Report to the Sydney Central City Planning Panel

DA number	JRPP-16-03306	Date of lodgement	31 March 2016
Applicant	Brooks Projects Architects		
Owner	Li and Qing Unit Trust		
Proposed development	Construction of a part 3 and part 4 storey residential flat building containing 106 apartments, 2 levels of basement car parking, associated landscaping and stormwater drainage works		
Street address	Grange Avenue, Marsden Park (proposed lot 7 approved by DA-15-02309 currently lot 9 DP 802880)		
Notification period	26 April 2016 (14 days)	Number of submissions	1

Panel criteria (section 9.1 Direction, EP&A Act)	Capital investment value (CIV) over \$30 million (DA has CIV of \$23,294,004 million)
Report prepared by	Bertha Gunawan
Report date	12 July 2018
Recommendation	Deferred commencement approval subject to conditions listed in attachment 7.

DRAWING:
LANDSCAPE PLAN

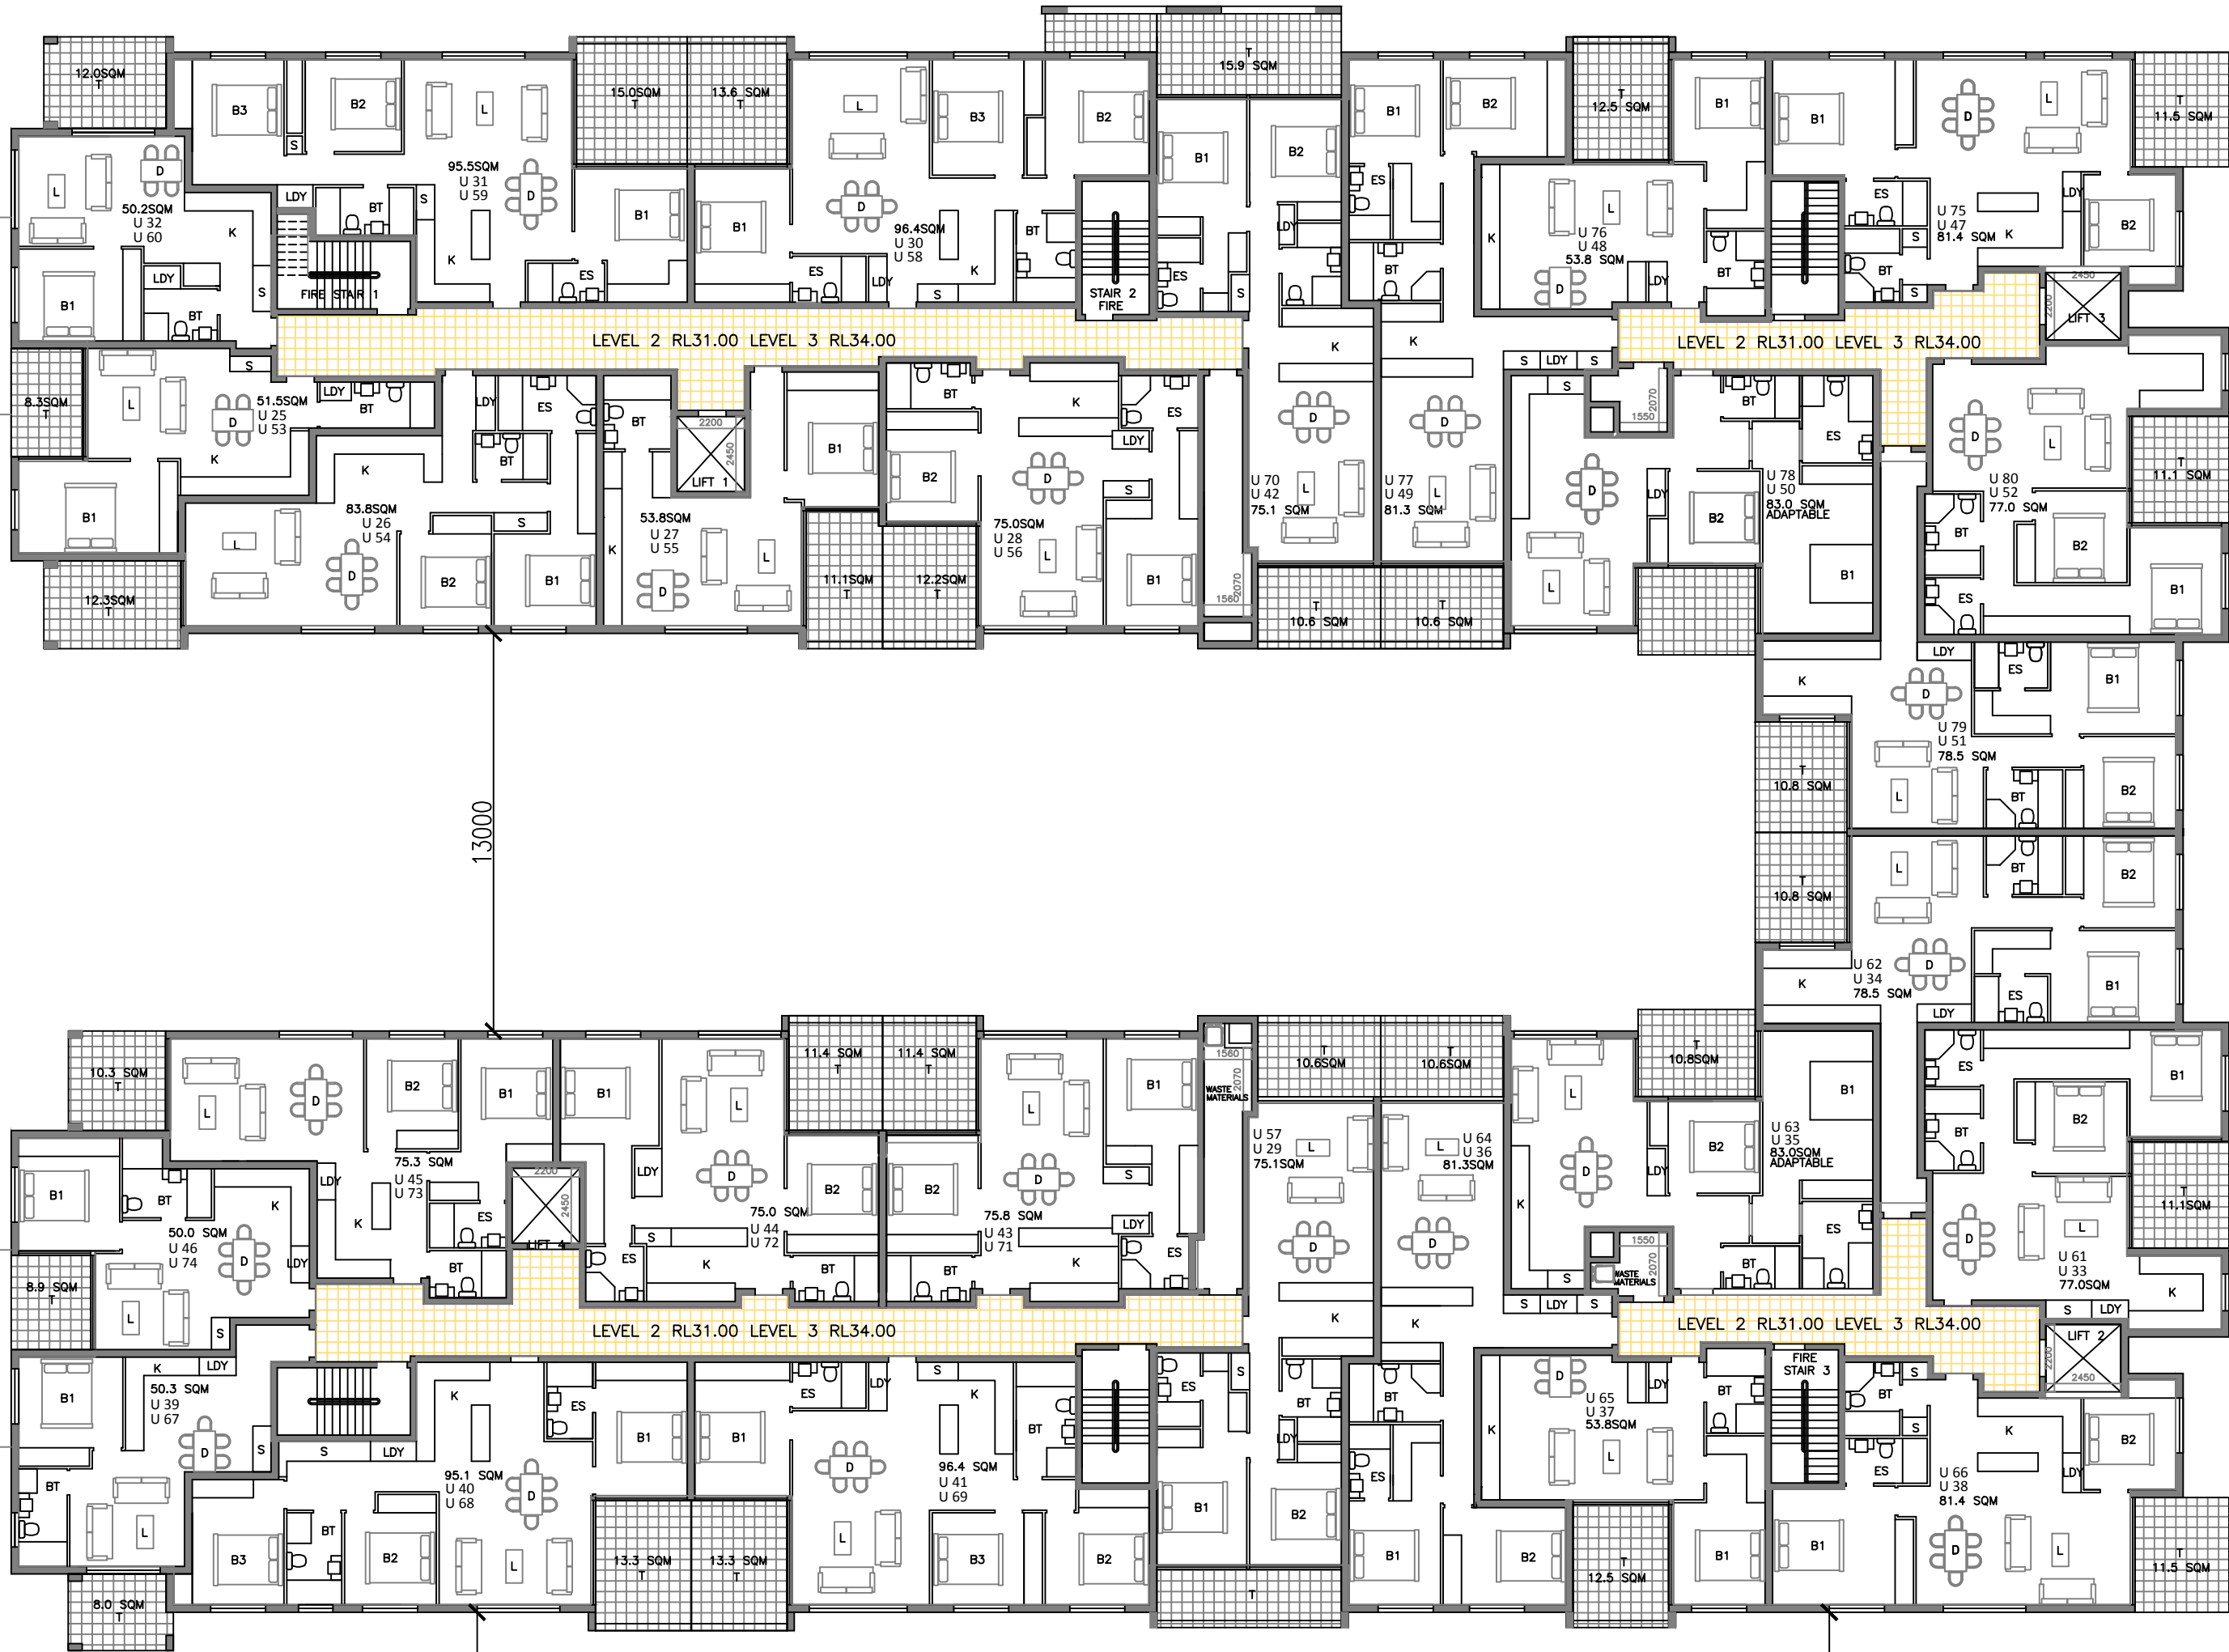
- In accepting the location and general provision of communal open space it is acknowledged however that the current landscape design does not achieve the objectives of Part 3D 'Communal Open Space' of the Apartment Design Guide for the full 25%, and that revised plans are required to ensure that a high quality space is delivered.

- Size of private terraces at Level 1 and their relationship to the communal open space to be better resolved
- Provide sections showing the relationship between the private balconies/terraces and the proposed communal open spaces

- Provide landscape detail and sections along the street frontages and all planting within the COS areas
- Provide details of the location of BBQ areas and seating and any other improvements to be delivered within the Communal open space for occupant's use

- There is no detail provided as to whether shading is to be provided over any of the deck areas
- Reduction in the amount of decked area is to be reduced and provision of detail as to how this space relates to the private terraces immediately adjoining them

- Ensuring that the architectural plans are consistent with the landscape plans in relation to the size and location of private terraces/balconies as they currently conflict

- The revised Landscape Plan will be required to be approved by Council prior to activation of the Development Consent.
